Attachment A1(b)

**Urban Design Study Part 2 – Waterloo
Estate (South) – City of Sydney**

The City of Sydney's Alternative Approach

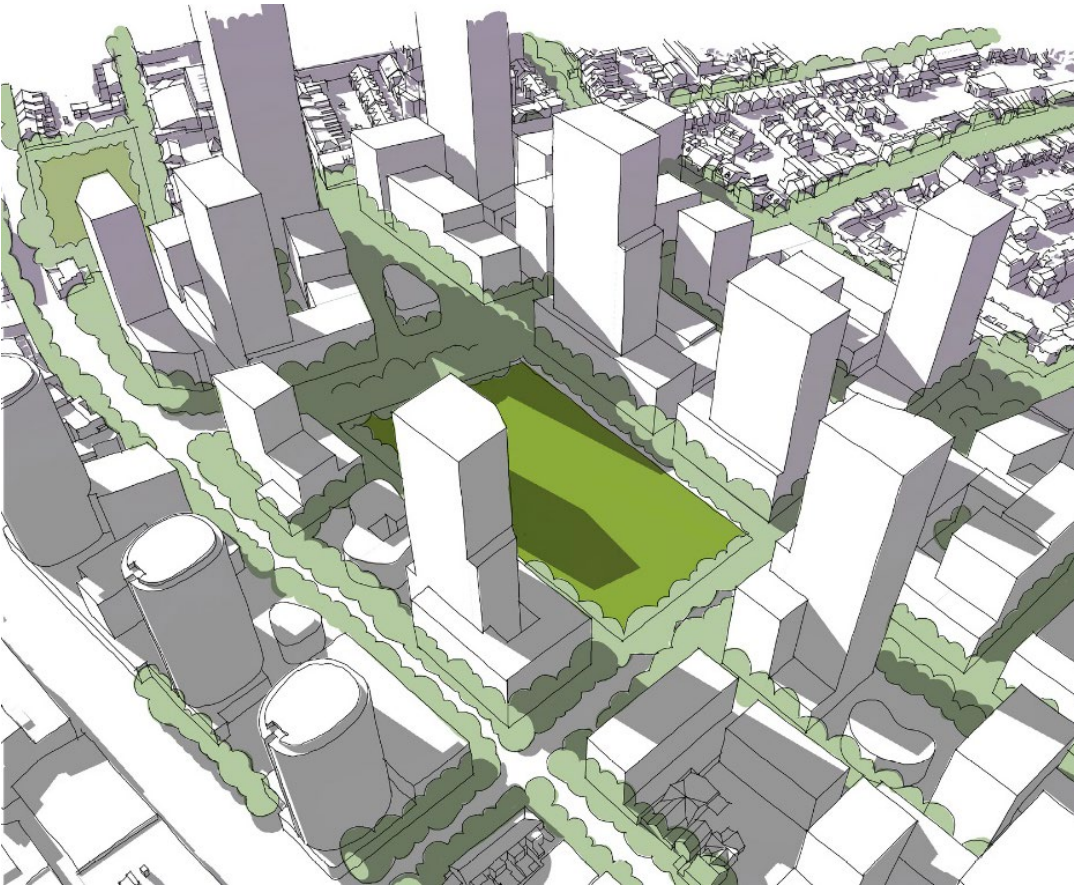
To meet this requirement, the Preferred Masterplan proposed to close George Street between Raglan and McEvoy streets – turning the street into parkland.

This is not acceptable to the City.

Closing George Street between Raglan and Wellington streets has several difficulties.

The park loses the definition of a street on its eastern side bringing park users and ground level users on the eastern frontage into conflict. The frontages need physical separation from the park for access, acoustic and visual privacy and safety [for example from a stray ball]. These conflicts are difficult to manage and usually result with alienation of the parks area or restricting its use. The alienation reduces the area available for recreation and restricting use of parks is difficult to manage and generally disobeyed creating conflict, banning ball play in a park is seen by most people as ridiculous.

Streets contain service lines owned and controlled by utilities. The utilities need be fully accessed without notice. This restricts tree planting, furniture and equipment placement and the like. These restrictions inevitably impede the planning and use of the park. This restriction is particularly unacceptable in the southern park where a large proportion of the park is centrally located in the path of George Street.

It was agreed to adopt the City's preferred park location of the full block between Cope, Raglan, George and Wellington streets incorporating Cope Street. The City agreed that a smaller park is to be located in south of the site to enhance access to parkland in this area a small part of which is just over 200 walking distance from the main park.

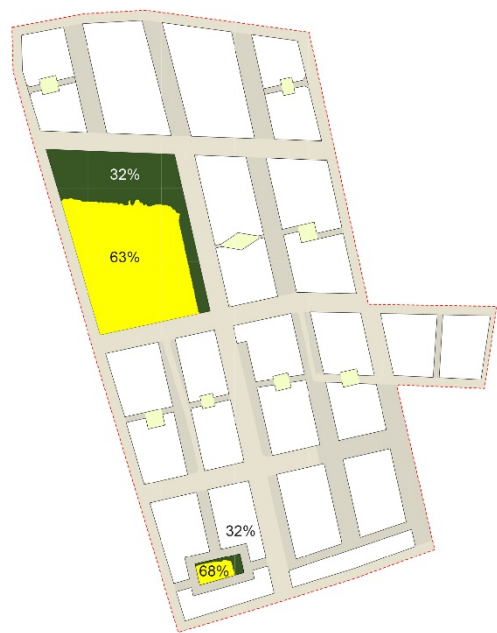
The George Street route was planned by LAHC to be diverted around the estate via McEvoy, Cope and Phillip streets. This is not acceptable to the City and Transport for New South Wales.

To operate successfully the route needs also to be straight and not divert, providing the most direct connection possible. Experience shows that diversions, such as that proposed by LAHC, are not followed by many users who continue to use the straight path to save time. This creates safety problems as fast travelling cyclists leave the pathways designed for their safety and the safety of other road users and conflict can result.

Separated bicycle paths exist in George Street, the Preferred Masterplan would remove these paths and replace them with longer new paths.

Transport New South Wales do not support adding separated bicycle paths to McEvoy Street as it conflicts with their current planning.

It was agreed to not move the existing regional bicycle path from George Street and to include the planned regional path along Wellington Street.

COMPARISON OF STREET NETWORKS – WIDTHS AND SUNLIGHT ACCESS

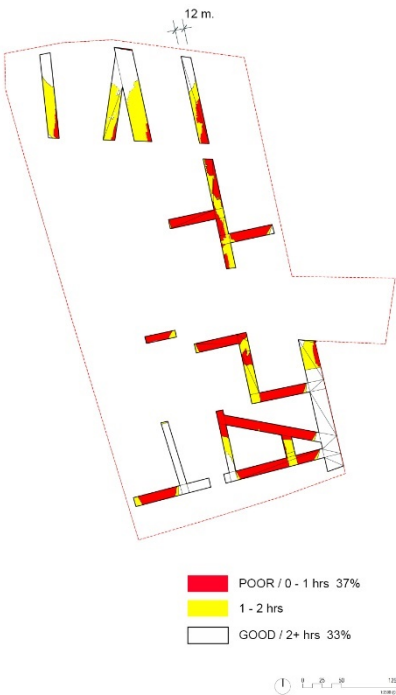
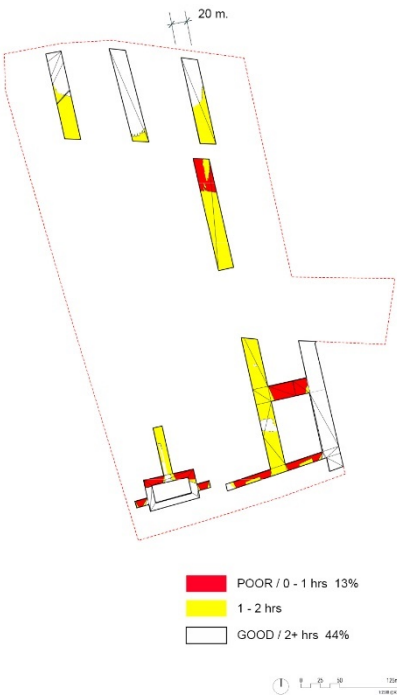
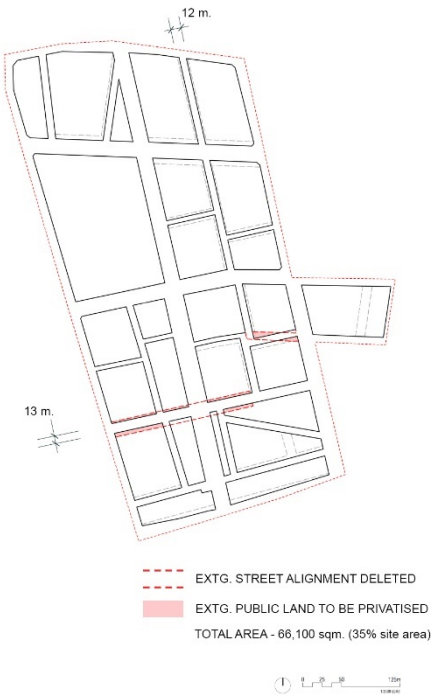
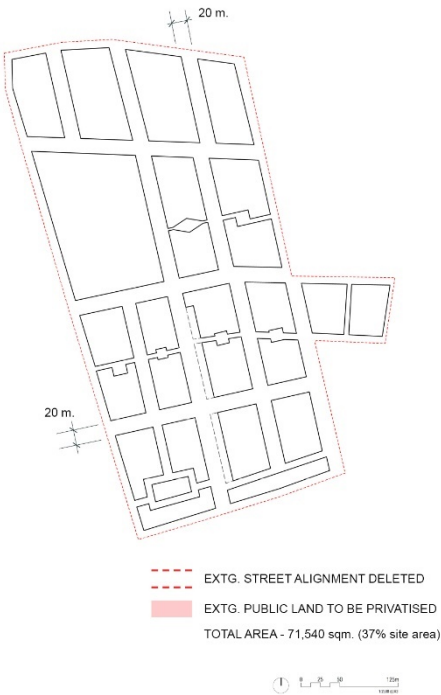
The Preferred Masterplan has generally narrower, with 6 and 9 metre street reservations in a generally 12 metre building to building, new streets evenly distributed in the east west and north south axes. The narrowness and the lack of hierarchy in orientation lessen the access to sunlight in these streets, particularly, in mid-winter.

Within the 12 metre building separation the proposed the street reservations proposed are generally 6 and 9 metres wide. These widths are suitable for shared zones in low use streets – streets that are not required for access to car parks and are located where low [10kph] speed zones are likely to be approved, for example around parks, but not elsewhere.

The Preferred Masterplan includes the narrowing the existing John Street reservation, from 20 metres to 13 metres, to increase the amount of developable land. Implement the narrowing requires a street closure; a complex, time consuming, uncertain legal and bureaucratic process; followed by service relocation and tree removal. John Street is managed and controlled by the City, its agreement to the narrowing was not sought during the design process and is not likely to be agreed. It also proposed closing Reeve Street and reopening it in a slightly different position in a slightly narrower reservation. This is also not acceptable to the City.

LAHC agreed not to narrow John Street, not to close and reopen reeve Street and to increase the width of West Street between Reeve and John streets.

WATERLOO ESTATE – LAHC’s PLANNING PROPOSAL REQUEST SCHEME

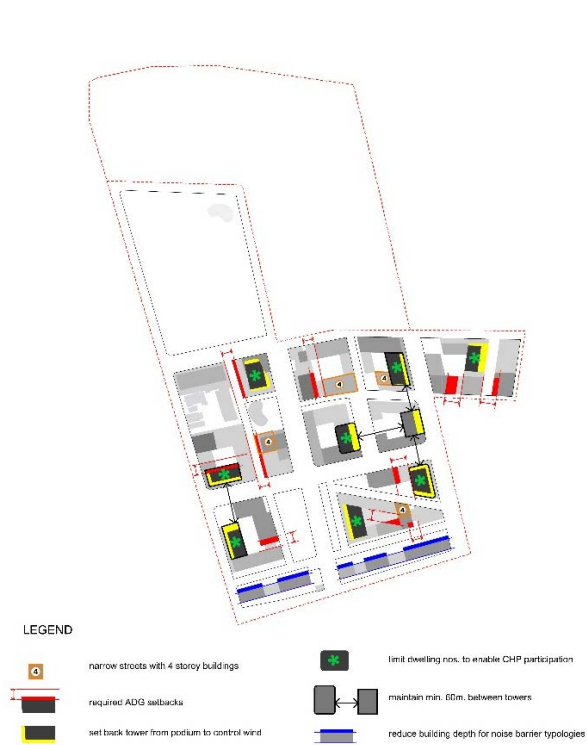
The following issues remain a concern:

- Some new streets and walkways are not accessible to people of all abilities as they run east west up the slope, rather than north south across it. This restricts access from the west of the site, isolating Pitt, West, Reeve and Kellick streets; and, areas south and west from the Pitt and McEvoy streets intersection, to the park and future Metro station.

- A preponderance of towers; nine towers, eight of around 30 storeys and, in addition, three fifteen storey buildings remain,
 - in some places these towers are located closer together than required by Sydney Development Control Plan 2012

- They do not have sufficient podium setbacks or other measures to protect the surrounding public spaces from wind downdraft
 - They limit sun access to streets, courtyards and lower buildings

- East-west orientation of new street layout limits solar access into new streets, lessening amenity and tree growth
- Some buildings do not meet the building separation criteria of the Apartment Design Guide

- George Street bisects the southern park unnecessarily, decreasing the usefulness of the park while necessitating two new streets either side of it that duplicate the traffic function of George Street thereby increasing the amount of land dedicated to streets

- the parks receive barely enough mid-winter sunlight and risks being undermined in future development proposals.

Matters of concern – streets and parks

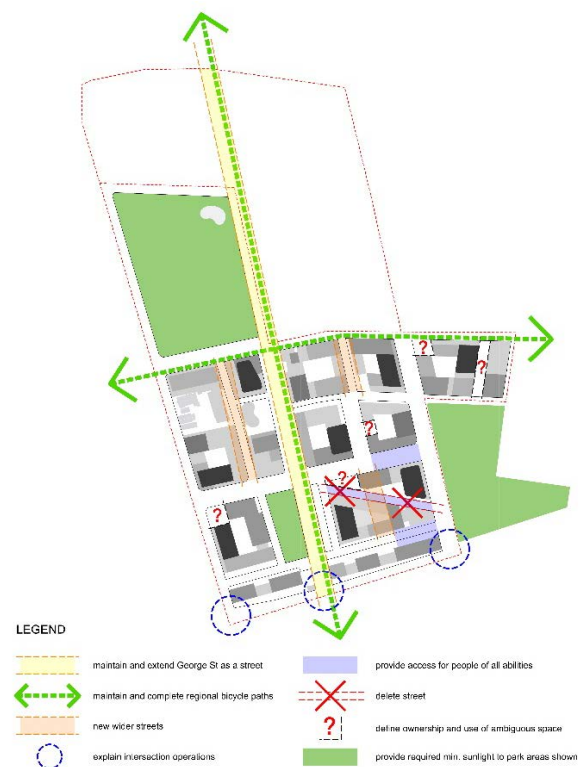
- Several setback areas are located on corners and lack definition between the public and private space creating ambiguous places that are difficult to manage
